Addendum #2

Facilities Roof Replacement

ADDENDUM NO. 2

PROJECT: Roof Replacement
UCPS Facilities Office

⑧ NEW ROOF SYSTEM
N.T.S.

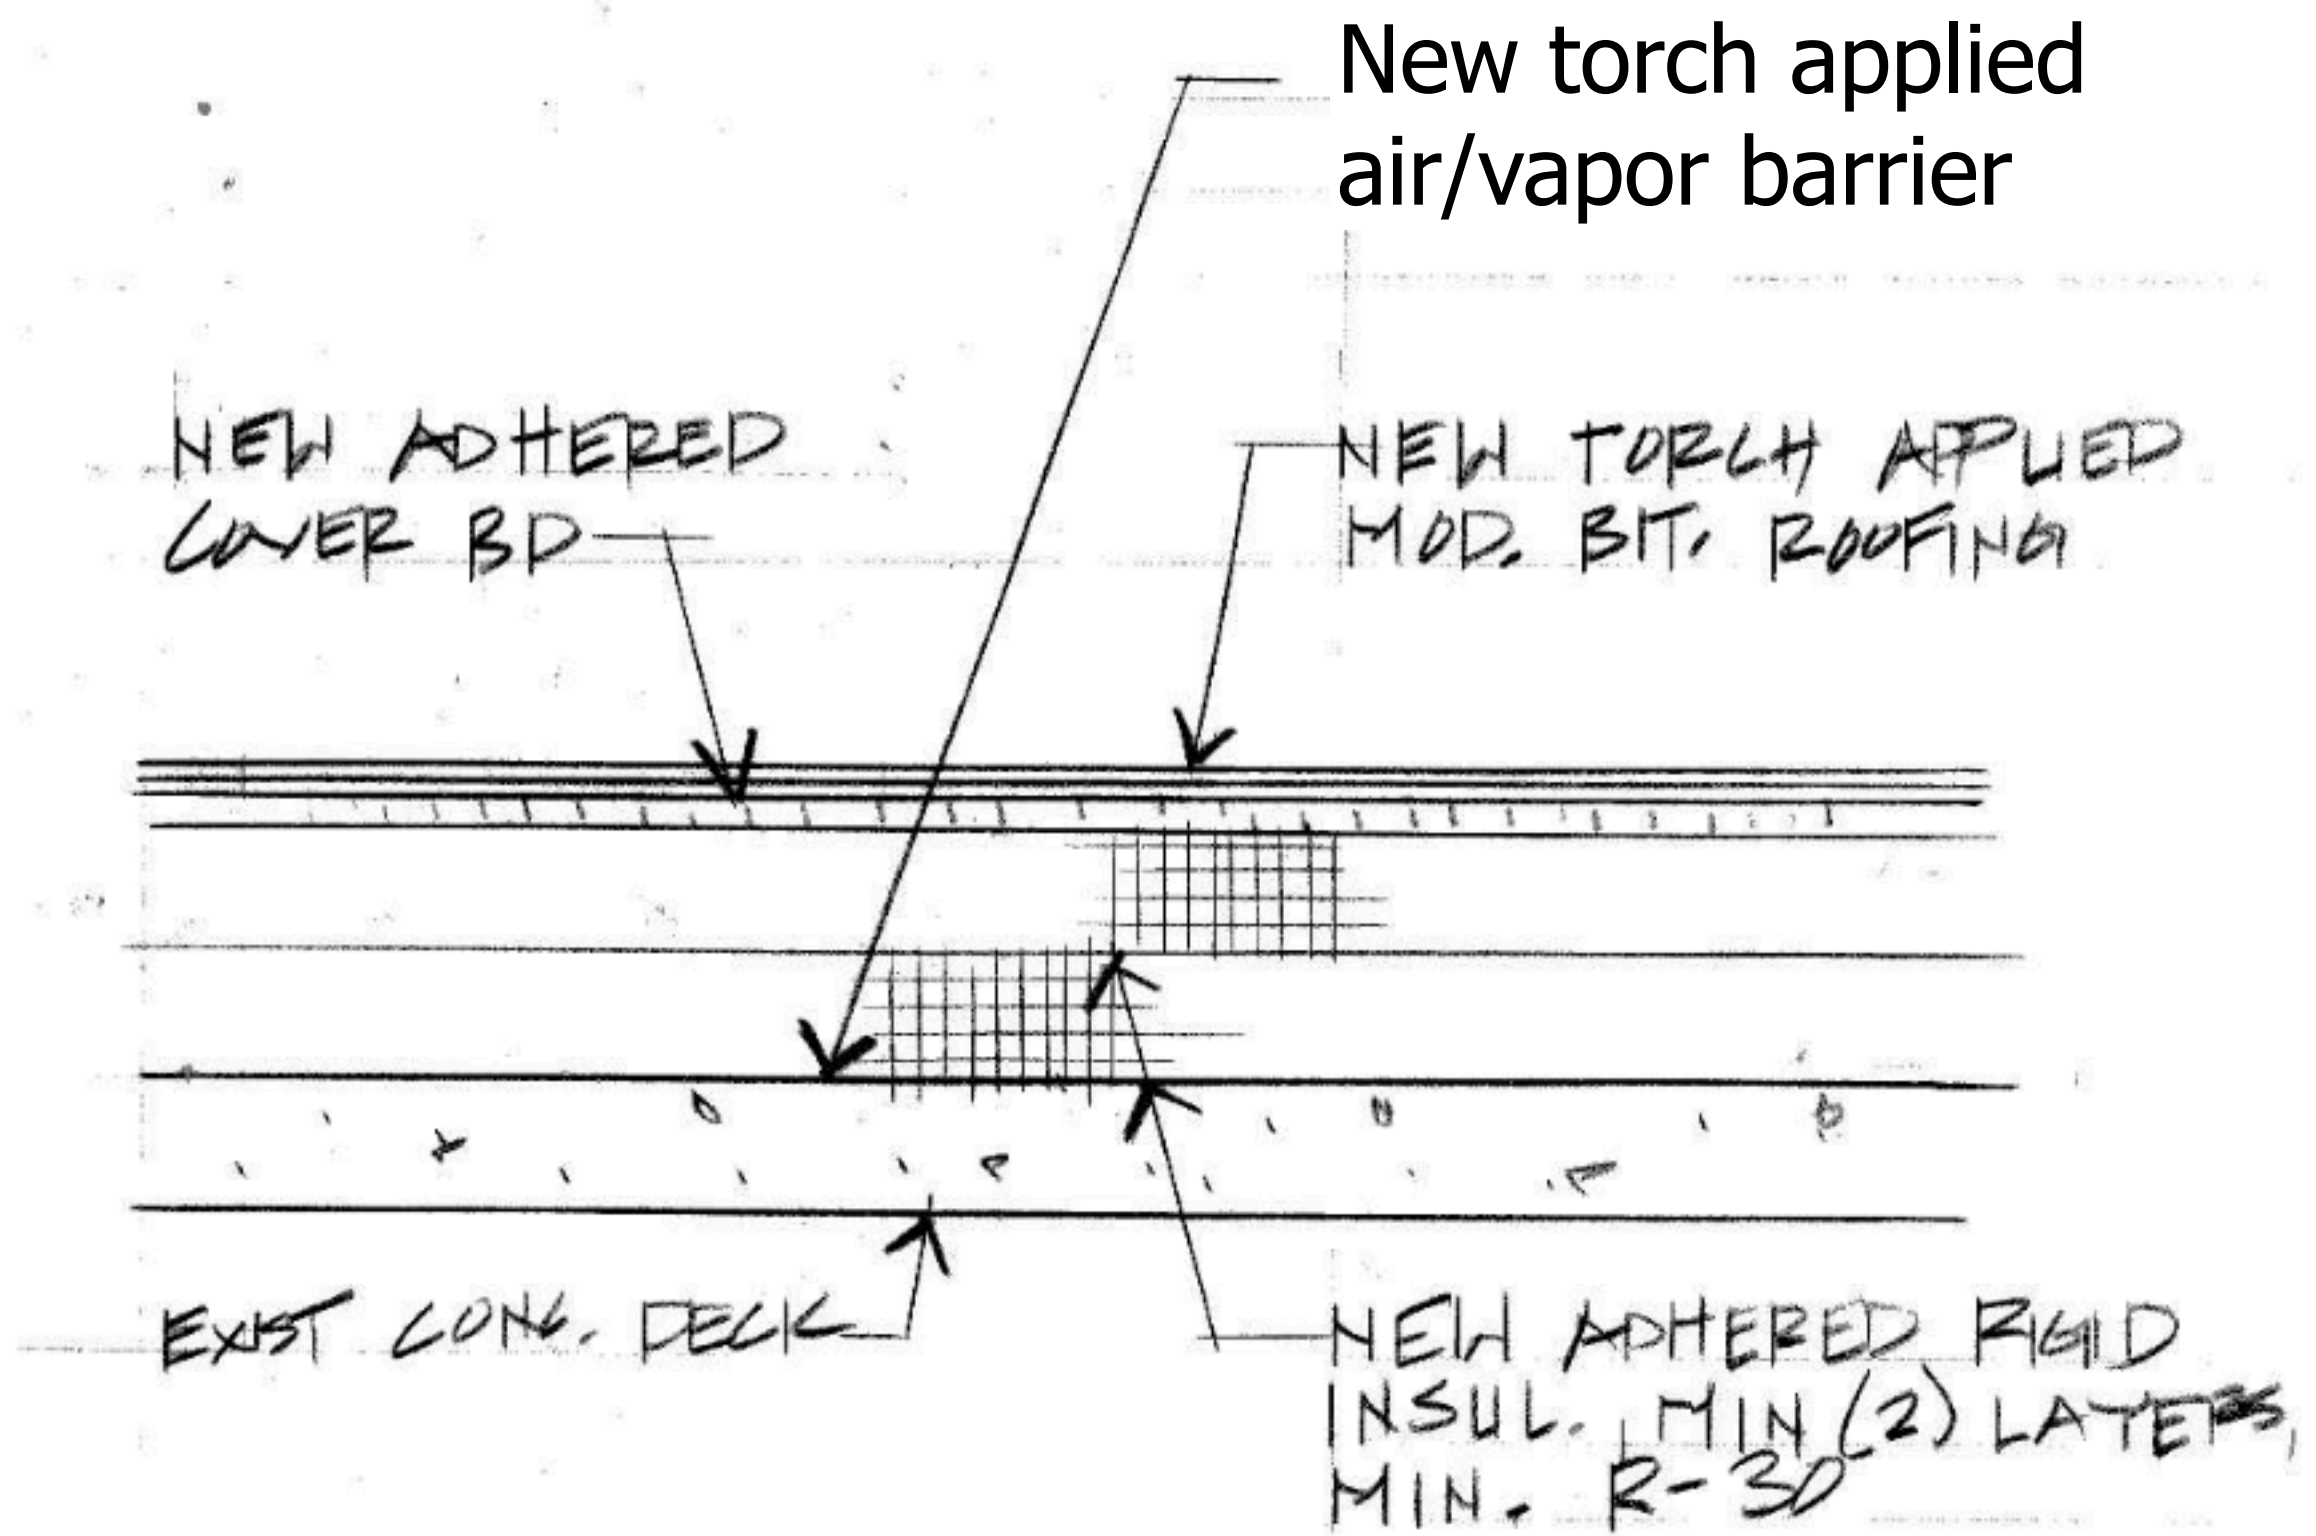
2. Sheet 2.0

a. Detail No. 8, change "New self-adhered air/ vapor barrier" to "torch applied air/ vapor barrier"
